FORM APPROVED  
OMB NO. 1004-0137  
Expires: January 31, 2018**SUNDRY NOTICES AND REPORTS ON WELLS**  
*Do not use this form for proposals to drill or to re-enter an abandoned well. Use form 3160-3 (APD) for such proposals.*

1. Type of Well <input checked="" type="checkbox"/> Oil Well <input type="checkbox"/> Gas Well <input type="checkbox"/> Other		8. Well Name and No. STEVENS B-17
2. Name of Operator APACHE CORPORATION		9. API Well No. 30-025-21921-00-S1
3a. Address 303 VETERANS AIRPARK LANE SUITE 3000 MIDLAND, TX 79705	3b. Phone No. (include area code) Ph: 432-818-1103	10. Field and Pool or Exploratory Area LANGLIE
4. Location of Well (Footage, Sec., T., R., M., or Survey Description) Sec 7 T23S R37E SESE 660FSL 660FEL		11. County or Parish, State LEA COUNTY, NM

\*\* BLM REVISED \*\* BLM REVISED \*\* BLM REVISED \*\* BLM REVISED \*\* BLM REVISED \*\*

**Permanent Abandonment of Federal Wells  
Conditions of Approval**

WELL BORE INFO.

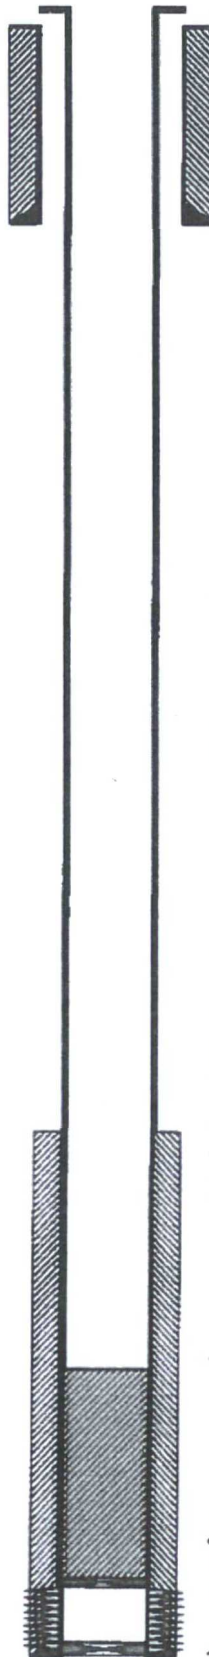
IF NO CIBP, Set one @ 3528, Cap w/ 25 sx. Then proceed to #1 Spot plug, Tag.

IF CIBP @ 3084', Proceed as per submittal.
